Access Compliance Report

Public Rights-of-Way

(Curb Ramps)

Intersection ID: 27270	Main Street: ELMSTONE_DR	Cross Street: SUMMITT_TREE_CT	Location: SW
ADA ID: ECF3F92C7590	Ramp Type: Perp	Initial Pass/Fail: Fail	Overall Compliance: No
Severity Score: 37.5			
Codes/Mitigation Info/Possible Solution		Field Measurements/Component Compliance

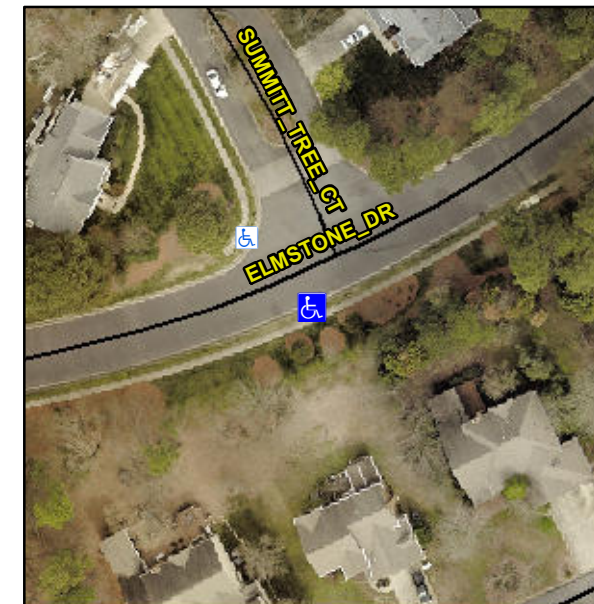
Not Found, R304.2.2, R304.5.3

Compliance	Description	Data	Compliance	Description	Data
N/A	Ramp Length (in)	48.0	No	Ramp Slope (%)	13.2
Yes	Ramp Width (in)	48.0	No	Ramp XSlope (%)	6.6
N/A	Flare Type LT	N/A	N/A	Flare Type RT	N/A
N/A	Flare Slope LT (%)	N/A	N/A	Flare Slope RT (%)	N/A
N/A	Flare Traversable LT?	N/A	N/A	Flare Traversable RT?	N/A
N/A	Landing Length (in)	N/A	N/A	DWS Provided?	N/A
N/A	Landing Width (in)	N/A	N/A	DWS Contrast?	N/A
N/A	Landing Slope (%)	N/A	N/A	DWS Length (in)	N/A
N/A	Landing X Slope (%)	N/A	N/A	DWS Full Width?	N/A
N/A	Landing Curb? (Y/N)	N/A	N/A	DWS Offset (in)	N/A
N/A	Shared Landing?	N/A			
N/A	Gutter Ponding?	N/A	N/A	Gutter Slope (%)	N/A
N/A	Gutter Lip Ht (in)	N/A	N/A	Gutter X Slope (%)	N/A
N/A	Painted X Walk1?	No	N/A	Painted X Walk2?	N/A
	X Walk 1 Direction	To NW		X Walk 2 Direction	N/A
N/A	X Walk 1 Width (in)	N/A	N/A	X Walk 2 Width (in)	N/A
	X Walk 1 Slope (%)	3.8		X Walk 2 Slope (%)	N/A
	X Walk 1 X Slope (%)	7.2		X Walk 2 X Slope (%)	N/A

Remove & Replace Entire Ramp.
